## 9.4 APPLICANT COMMENT LETTER AND RESPONSES

**Table 9.4-1. Applicant Comments**

**RE: Dana Reserve Specific Plan Draft Environmental Impact Report**

DRL-130

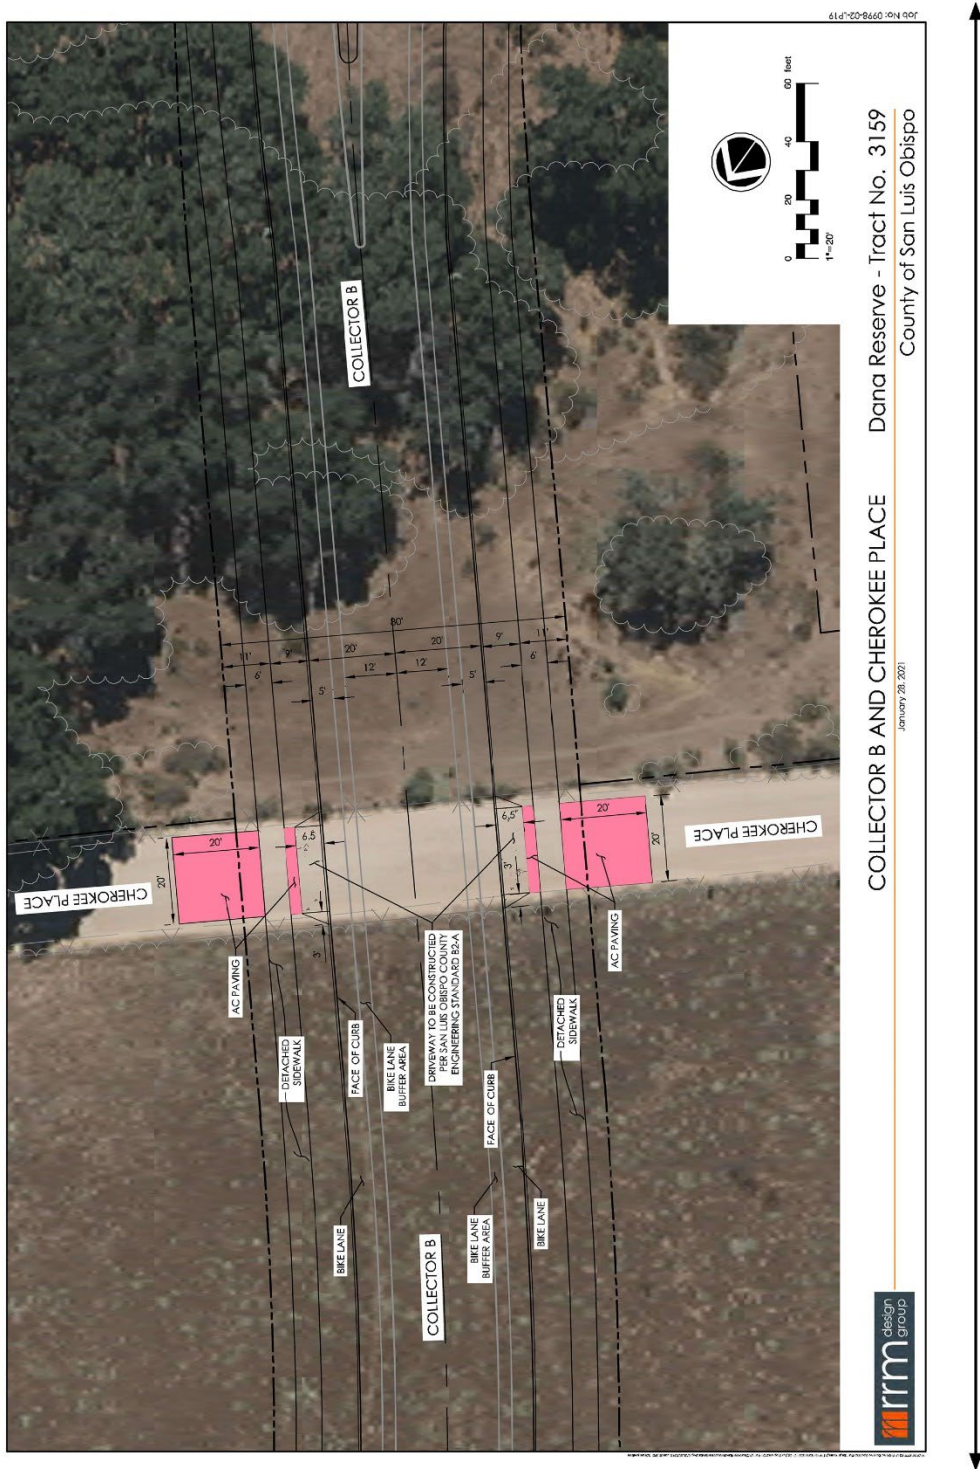
<b>Chapter 6: Other CEQA Consideration</b>		
6.2	Para 2	<p>Also include Pomeroy as another assess to this site.</p> <p>Section 6.1.3 How is preparation of a required Specific Plan for an area designated as a location for future growth a precedent setting Action? The language requiring the Specific Plan prior to development identifies commercial uses as an objective of the Specific Plan – how can these types of uses when proposed in the required DRSP be considered precedent setting?</p>
6.3	Para 1	<p>Why is this a Class 1? The discussion above indicates that this will be an infill project with annexation to NCS D and Nipomo URL.</p> <p>This project is consistent with SCAP, RHNA, and many other policies.</p> <p>Please remove this Class 1 impact.</p>
